**NextBridge Interrogatory # 1**

EB-2017-0364 - February 15, 2018 HONI Lake Superior Link Application

EB-2017-0364 – Hearing of Motion – Technical Conference HONI Undertaking Response JT2.30.

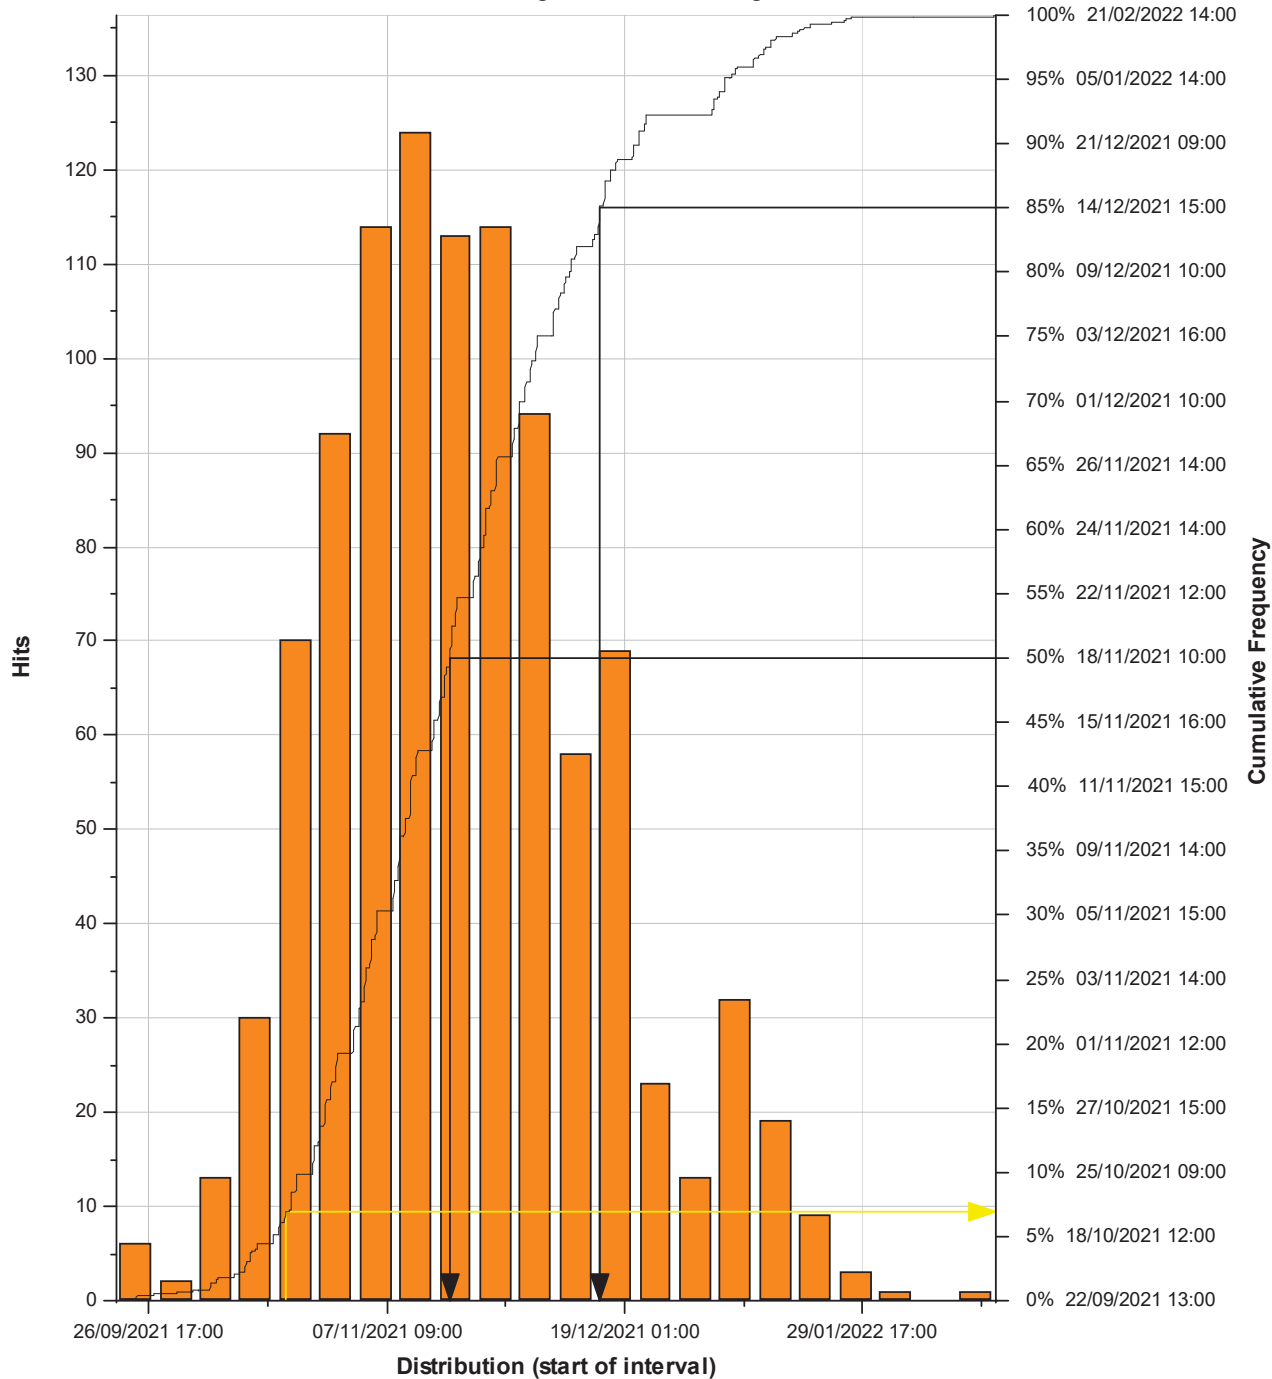
Please update and resubmit the probabilistic Monte Carlo analysis used to confirm the LSL schedule for both the preferred route through Pukaskwa National Park and alternative route around Pukaskwa National Park.
